Homestake Mining Company of California

July 10, 2026

**RE: Responses to the Request for Additional Information on the Discharge Permit
Renewal, DP-200, Homestake Mining Company, Grants Reclamation Project**

Attachment D - Figure 3.1-2 Site Topo and General Features

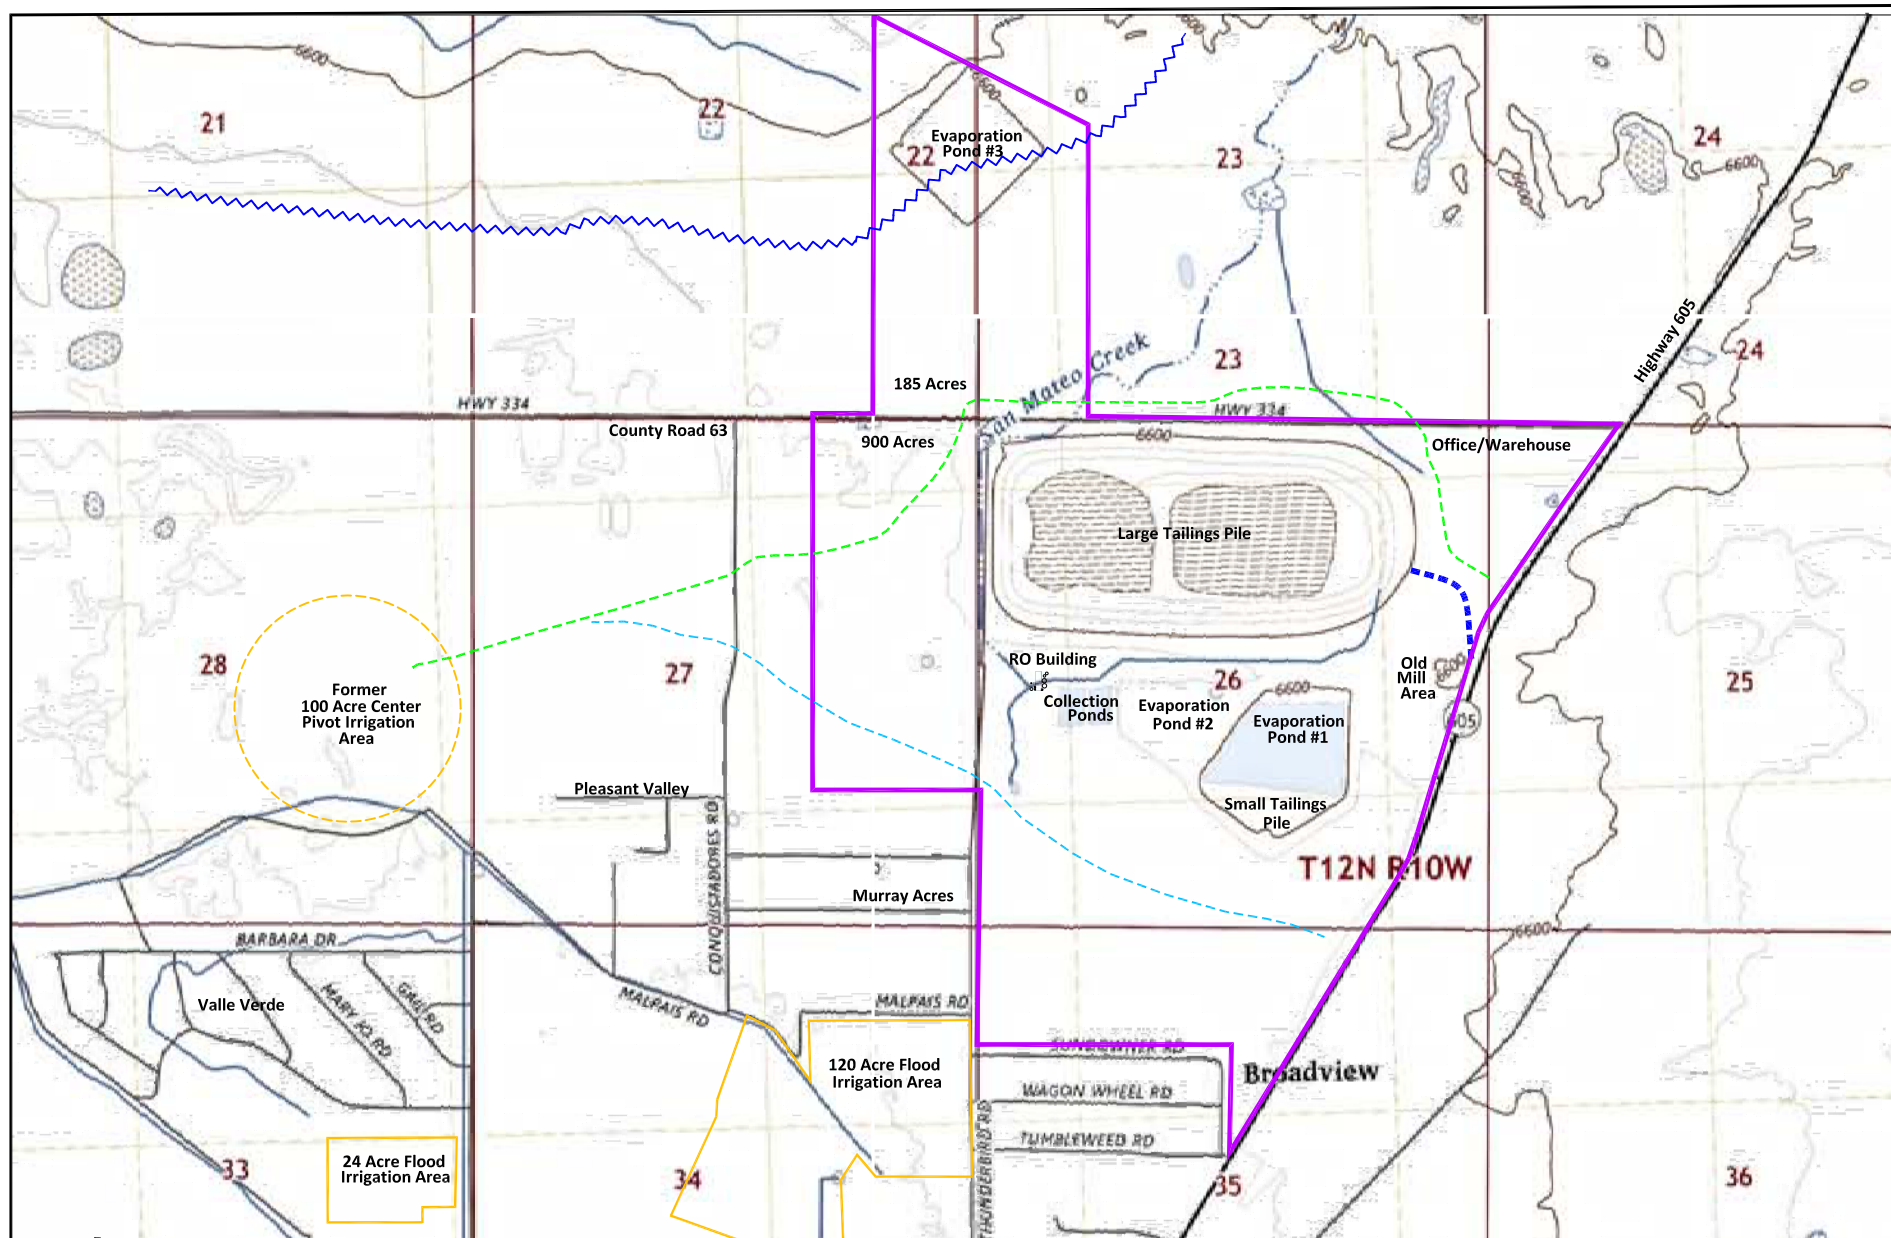
4. Part I, Administrative Completeness, 5. Please provide an updated table showing the location of all treatment facilities and ponds onsite (e.g., EP-3, etc.). Please also provide the maximum pond volumes and a description of the leak detection systems and their operation.

Also included with this Response is **Attachment D** Figure 3.1-2, which is a map depicting the location(s) of all treatment facilities and ponds on the Grants Site. The locations of Grants Site ponds and the Reverse Osmosis (R.O.) treatment facility are shown in Figure 3.1-2. Evaporation Pond No. 1 (EP1) has not been in service since 2024. Evaporation Pond No. 2 (EP2) has a maximum volume of 320.2 ac-ft and is in active use. Evaporation Pond No. 3 (EP3) has a maximum volume of 265.7 ac-ft and is in active use. EP3 has two cells (EP3A and EP3B). The West Collection Pond (WCP) has a maximum volume of 12 ac-ft and is in active use. The East Collection Pond (ECP) has not been in service since 2020.

- The map requested in response to Request No. 2, included as **Attachment A**, which depicts land ownership as of July 10, 2026;
- The map requested in response to Request No. 4, included as **Attachment D** Figure 3.1-2, which depicts all treatment facilities and roads at the Grants Site; and

Attachment E - Figures 1, 1a, 1b, 1C Well Locations

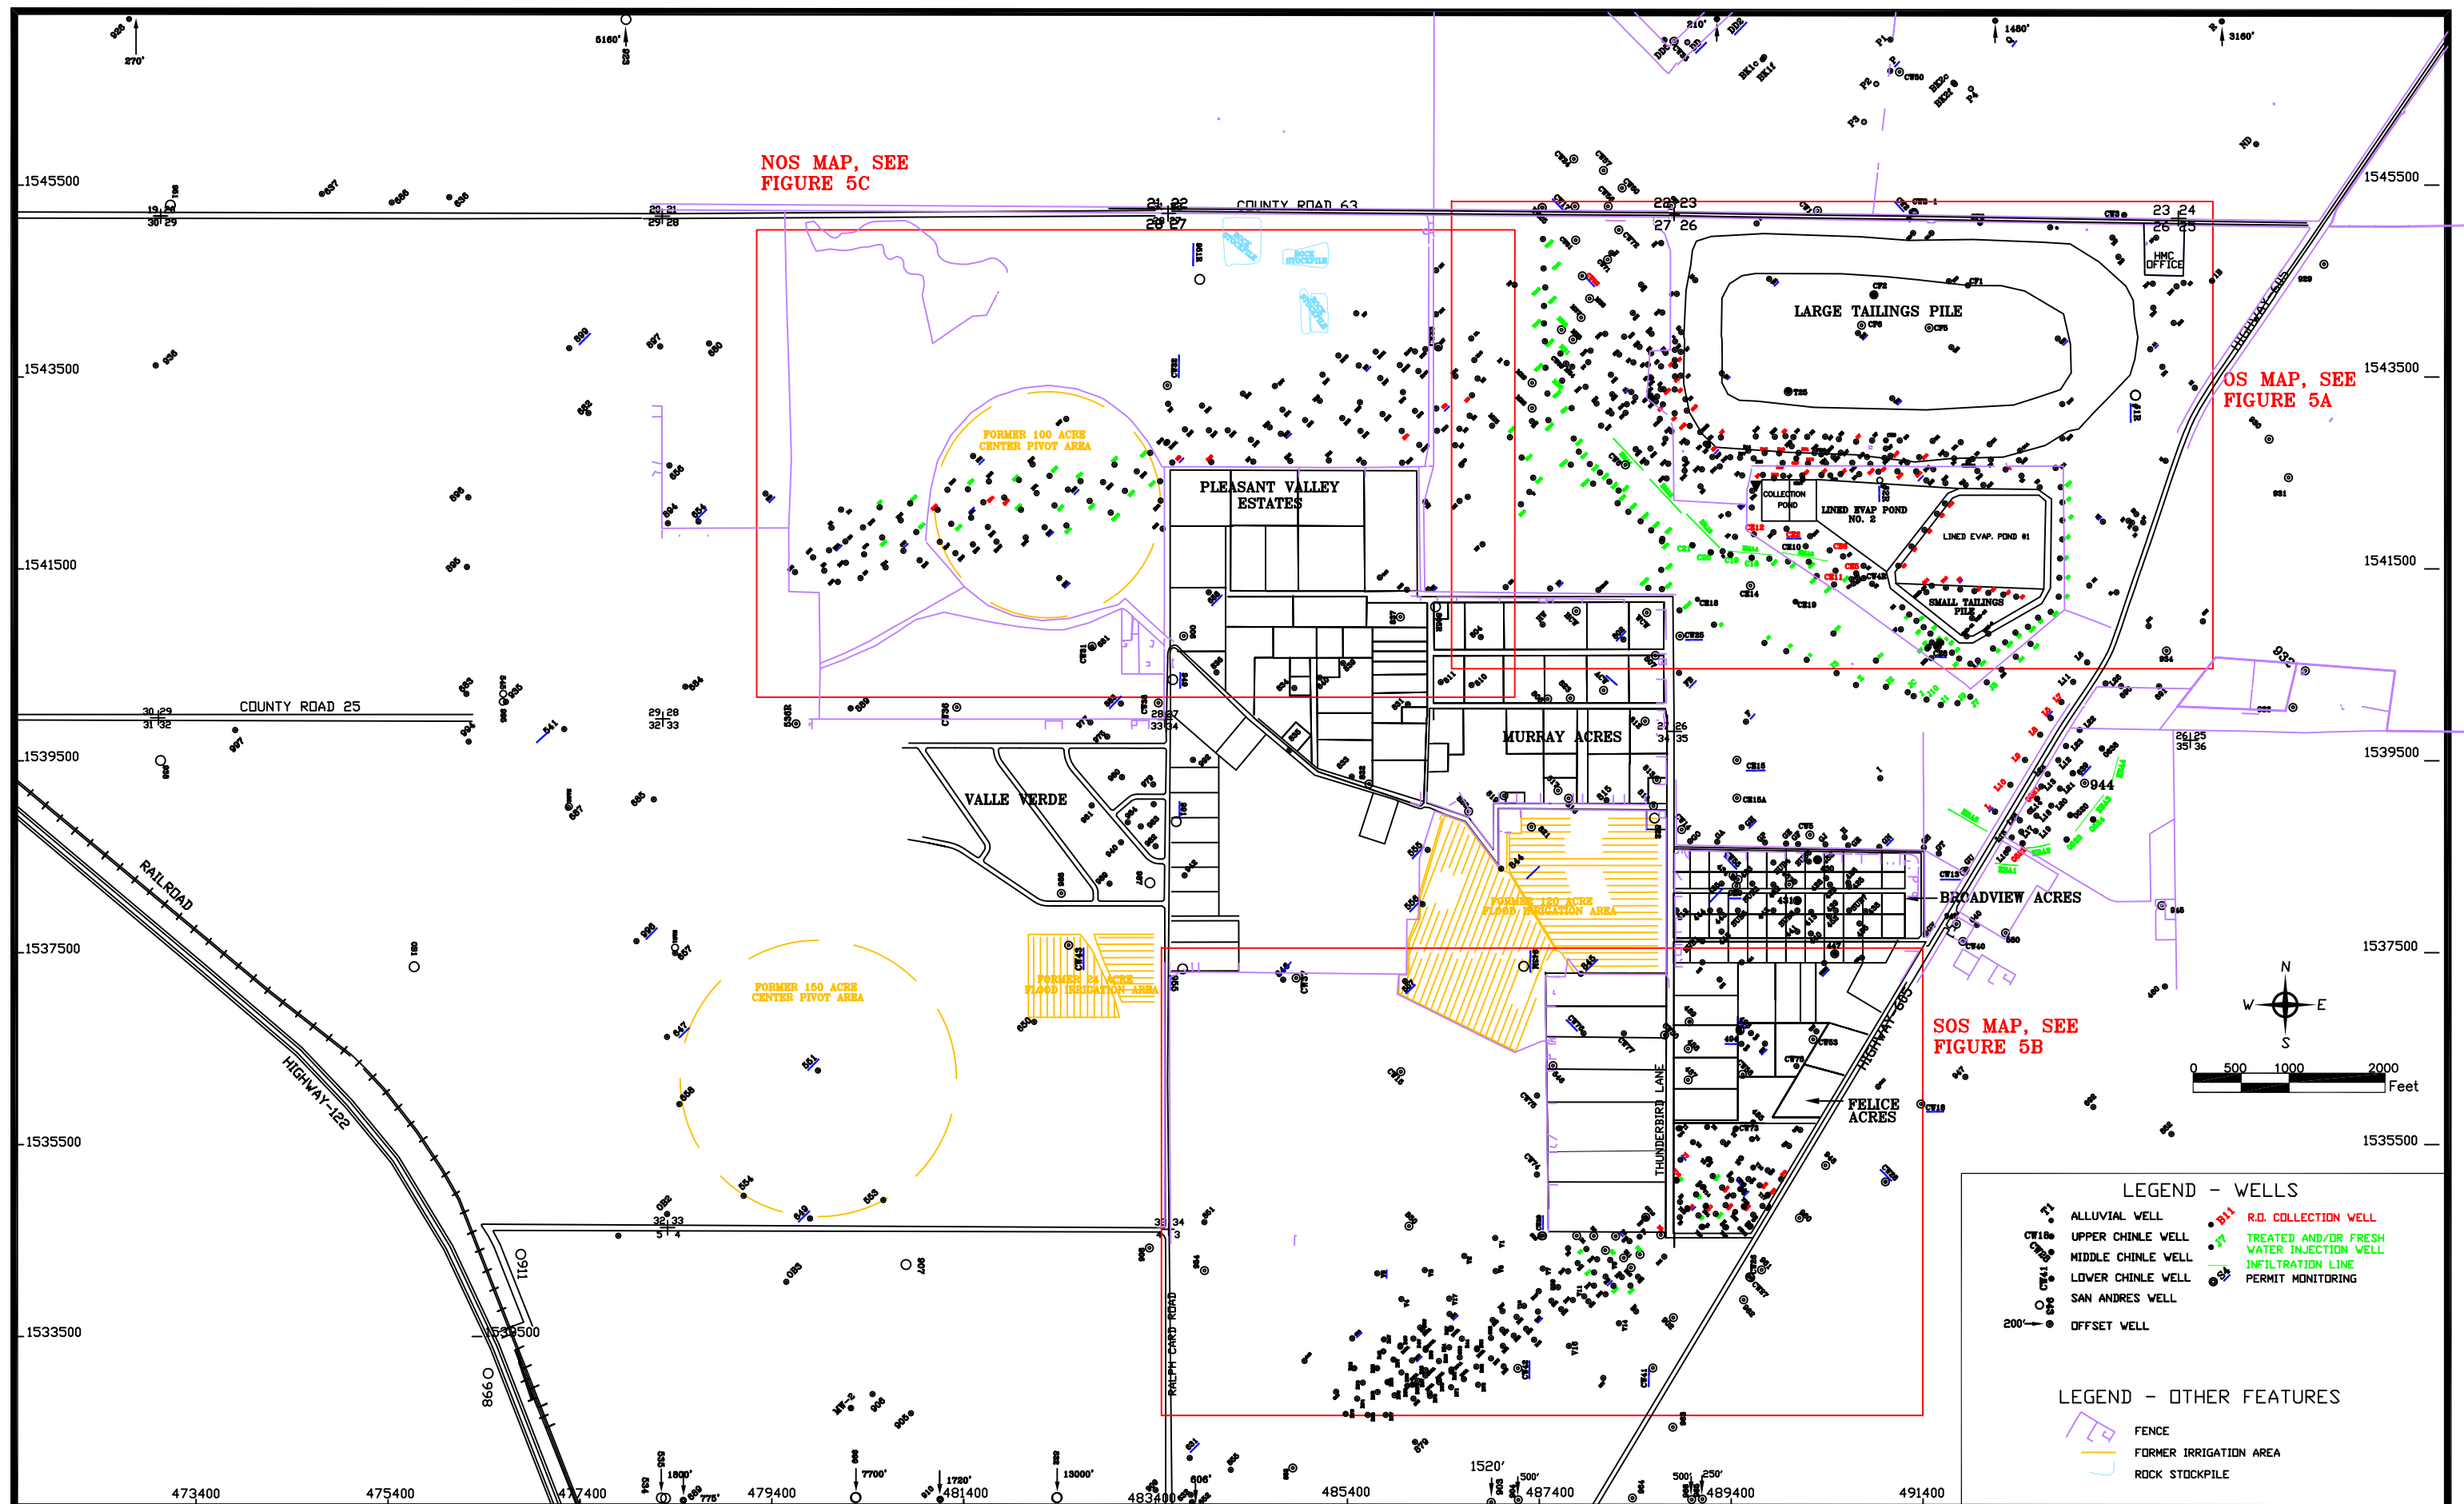
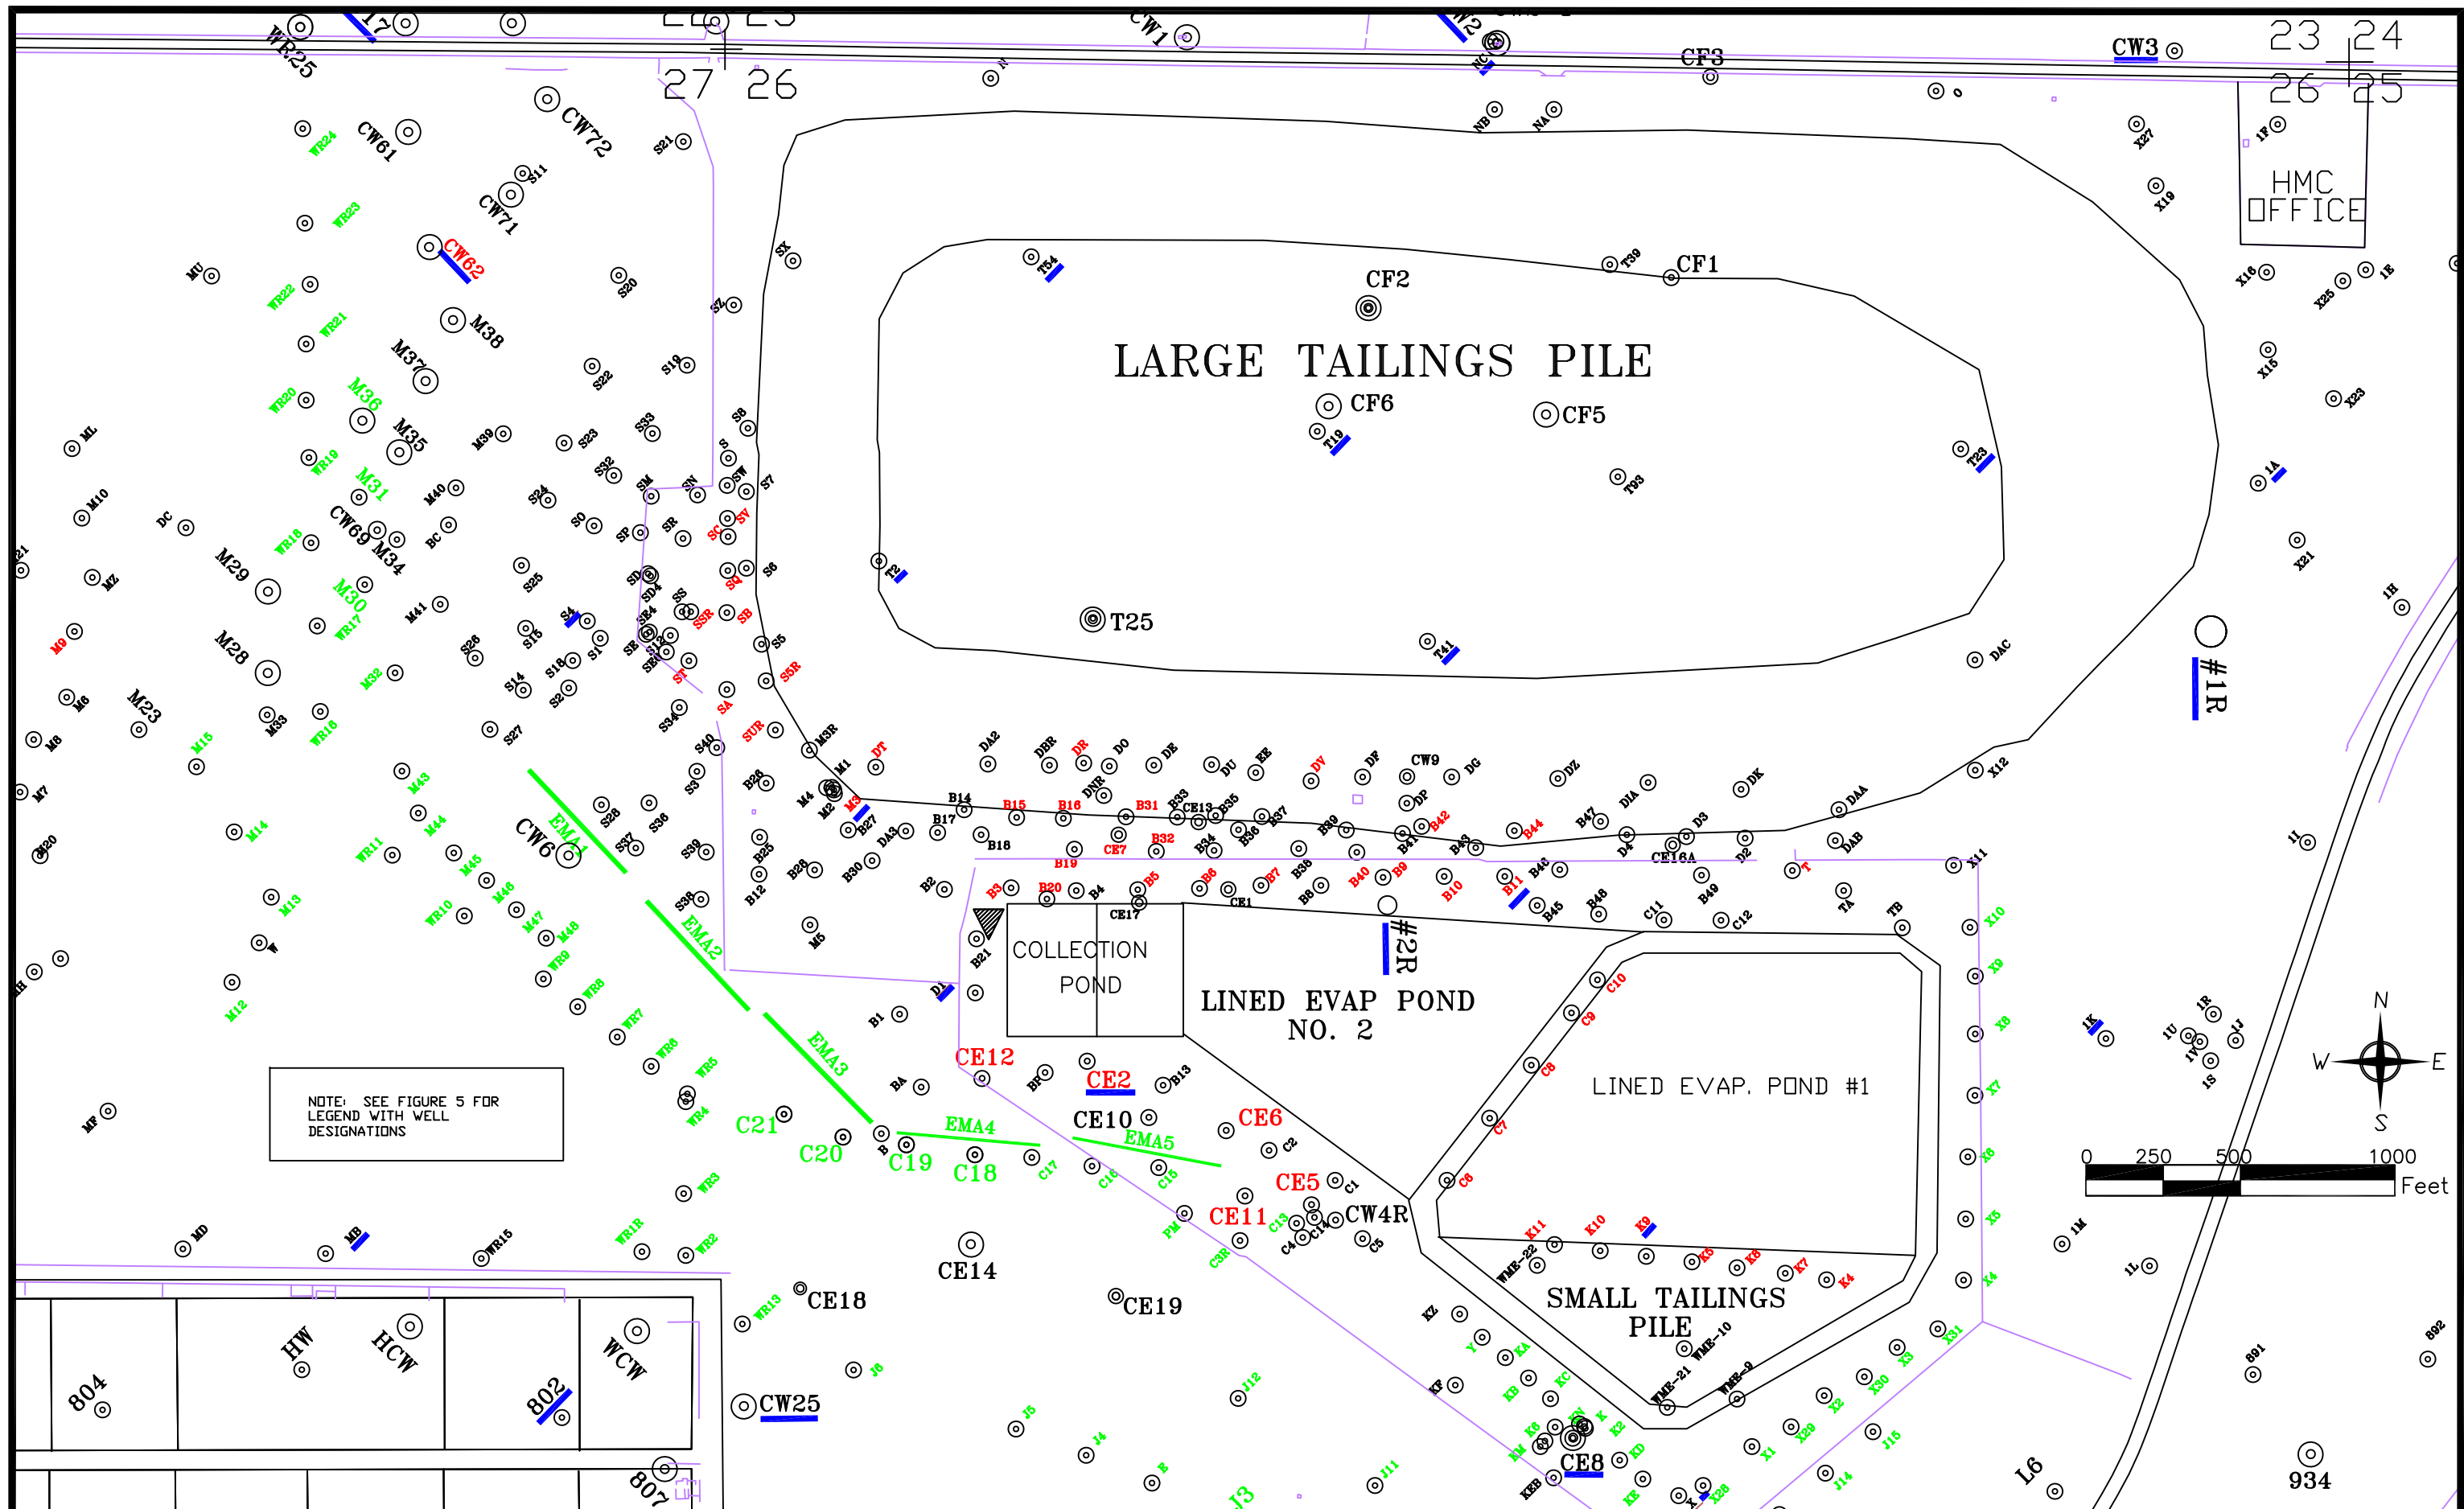
8. Part II Technical Completeness, 2a. Please provide updated maps, to replace and update those initially included in the 2019 discharge permit renewal application.

15. Part III Additional Proposals and Conditions. Please provide an updated underground injection control (UIC) listing of wells as required by Discharge Plan Condition 48 (DP-200 amendment 14-01 dated December 30, 2014). The recent Quarterly UIC Reports list wells that do not match what is shown in the Annual Monitoring Reports / Performance Reviews. For example, the 3rd Quarter 2024 UIC Report dated October 31, 2024, lists wells that do not match what is shown in Figures 4.1-1, 4.1-1A, 4.1-1B, and 4.1-1C in the 2024 Annual Monitoring Report / Performance Review. Specifically, well 496 is listed as active but not listed as an injection well in Figure 4.1-1B. Well 655 is listed as active but not listed as an injection well in Figure 4.1-1C. Infiltration line RCR7 is listed as active but not listed as an active infiltration line in Figure 4.1-1B. Please provide a map identifying the UIC-listed wells, along with an operational plan describing the planned use of each UIC well.

- **Attachment E** contains Figures 1, 1A, 1B and 1C which are an update to Figure 1 in the 2019 Application and show the current location of collection and injection wells at the Grants Site.

Part III does not expressly require information related to UIC wells. However, please find included herein **Attachment E**. This Attachment lists the UIC wells and depicts the location of all UIC-listed wells.

Attachment E presents the location of wells for the Grants Site with green labels indicating potentially active injection wells or recharge lines. The injection capacity of the injection sites shown as potentially active exceeds the supply of R.O. product water, and only a portion of the injection sites will be used at any given time. A priority for operation has been assigned to groups of wells and recharge lines to distribute the injection water to areas where it will contribute to hydraulic containment and/or general groundwater restoration. The priority system has been developed by general area (On-Site, South Off-Site and North Off-Site) and by location within that area. Because there are a large number of injection wells and recharge lines available, a specific operational plan is not presented for each well or recharge line, and some of the available wells or recharge lines shown on the associated map figures may not be used. There may also be infrastructure and distribution system constraints that affect utilization of some injection sites, so the priority system is used to manage the injection program. Given these
